COMBUSTION ENGINEERING

February 6, 1987
LD-87-009

Subject: Auxiliary Pressurizer Spray System for CESSAR-F

Proposed Design Modifications to the APSS

FIGURE 2

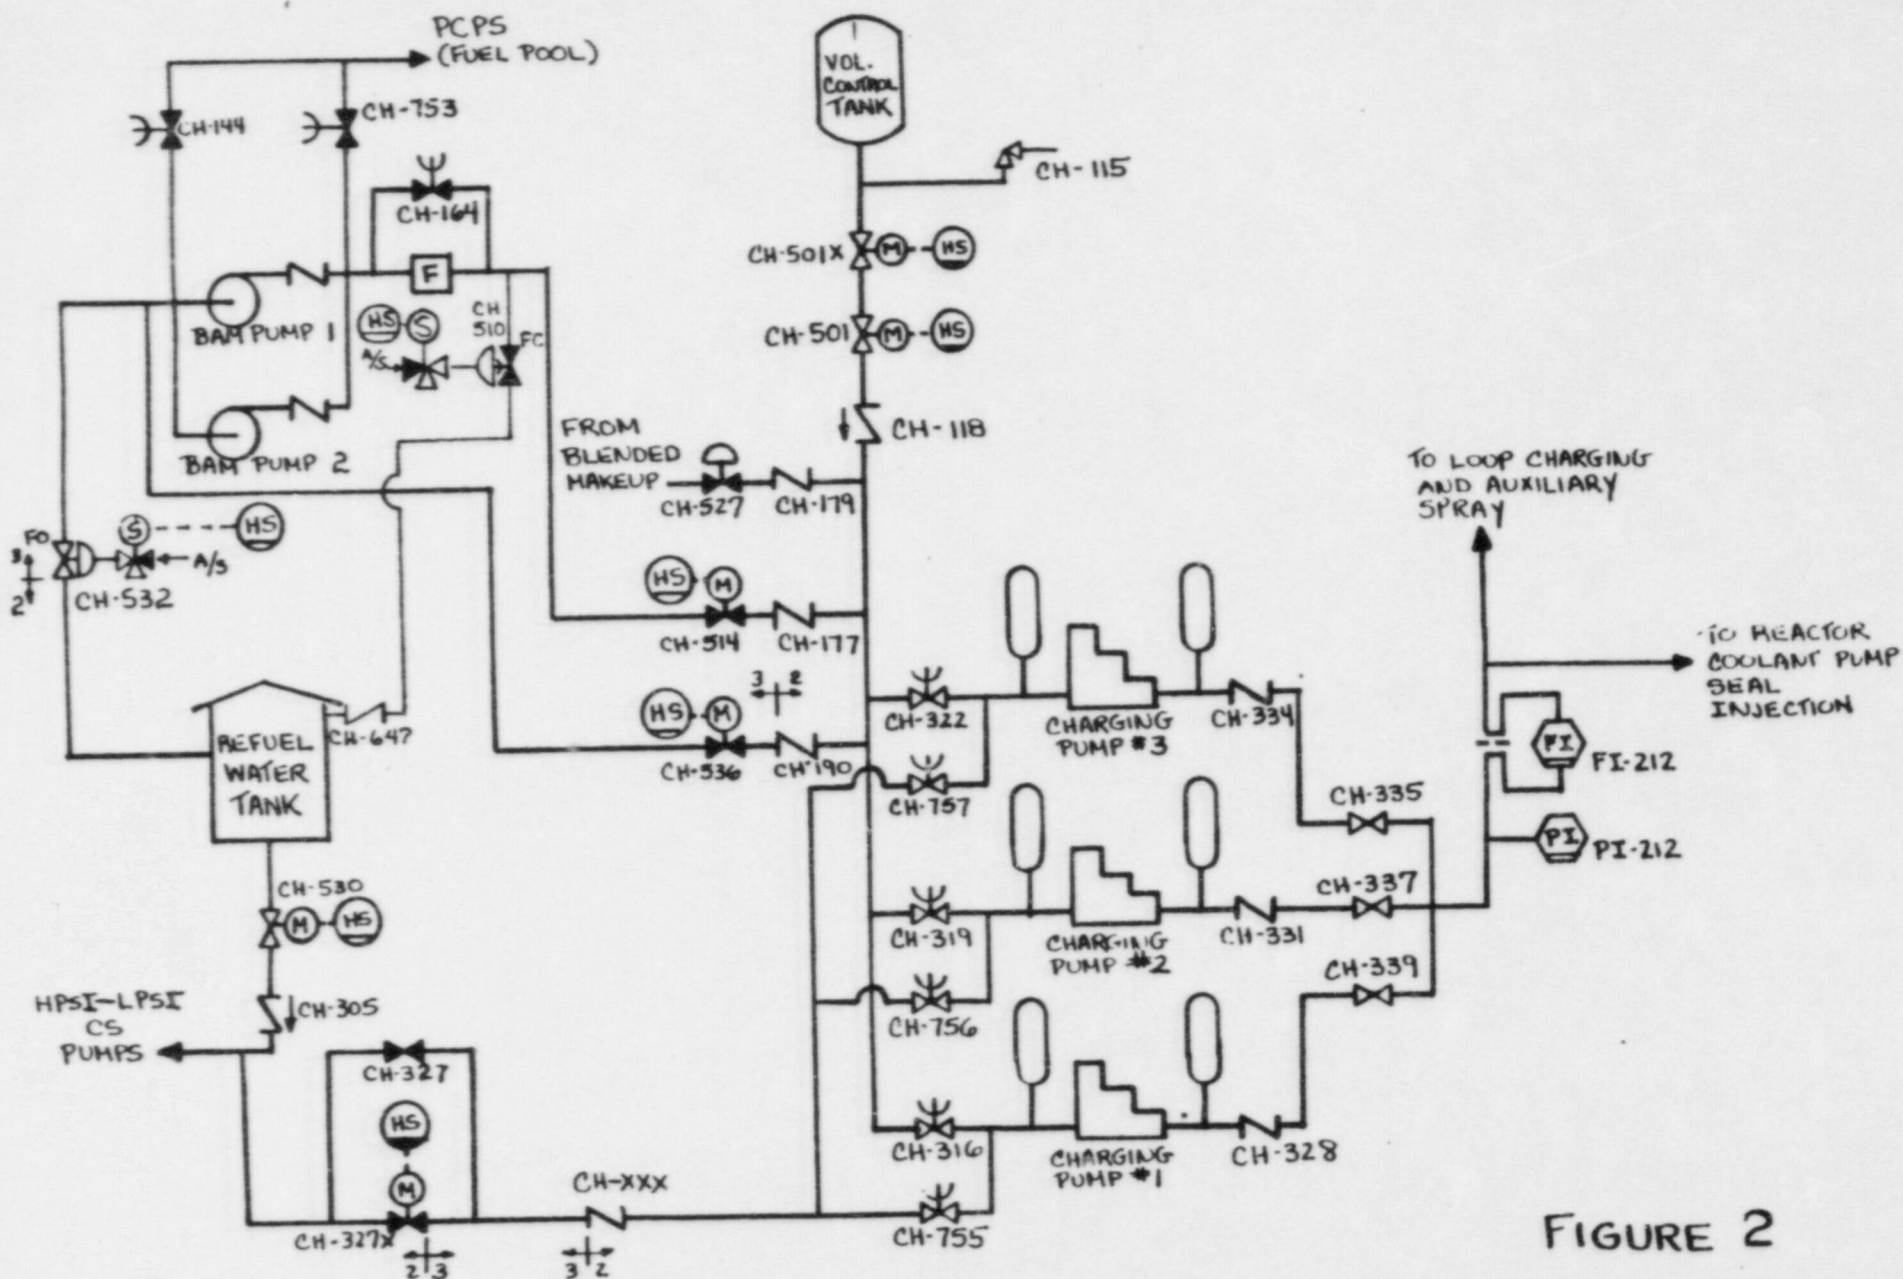
3. Add a second motor operated valve in series with the VCT outlet valve (This valve has been designated CH-501X in Figure 2).
4. Both CH-501 and CH-501X shall be capable of receiving power from an emergency 1-E supply (CH-501 from Train A and CH-501X from Train B). Power supplies to these valves shall be non-interruptible, i.e., shall not be shed on SIAS, for example. Handswitches shall be provided in the control room for remote operability of the valves.

5. CH-501X shall close on low-low level as indicated by L-226; CH-501 shall close on low-low level as indicated by L-227.
6. CH-536 shall be capable of receiving power from an emergency 1-E supply (Train A). Power supply to this valve shall be non-interruptible, i.e., power shall not be shed on SIAS, for example.

7. CH-536 shall open on low-low level on L-227.
8. Add a motor operated valve in parallel with CH-327 (Valve CH-327X in Figure 2). CH-327X shall be capable of receiving power from an emergency 1-E supply (Train B). Power supply shall be non-interruptible, i.e., shall not be shed on SIAS, for example. A handswitch shall be provided in the control room for remote operability of the valve.

9. CH-327X shall open on low-low level on L-226.
10. Add a check valve downstream of CH-327X and CH-327 (Valve CH-XXX on Figure 2). Piping downstream of CH-XXX shall conform to ASME Class 2, including CH-755, CH-756, and CH-757. Valves CH-755, CH-756, and CH-757 shall be normally open. (Current piping between CH-327 and CH-755, 756, 757 is ASME Safety Class 3)

13. The switch over from the VCT to an alternate suction source on low-low level shall be interlocked to prevent the possibility of a charging pump taking a suction on an isolated or partially closed section of pipe. Closure of CH-501 and 501X would be delayed until either CH-536 (or 514) or CH-327X reached full open position. Automatic closure of CH-501 and 501X would not occur except on low-low VCT level.
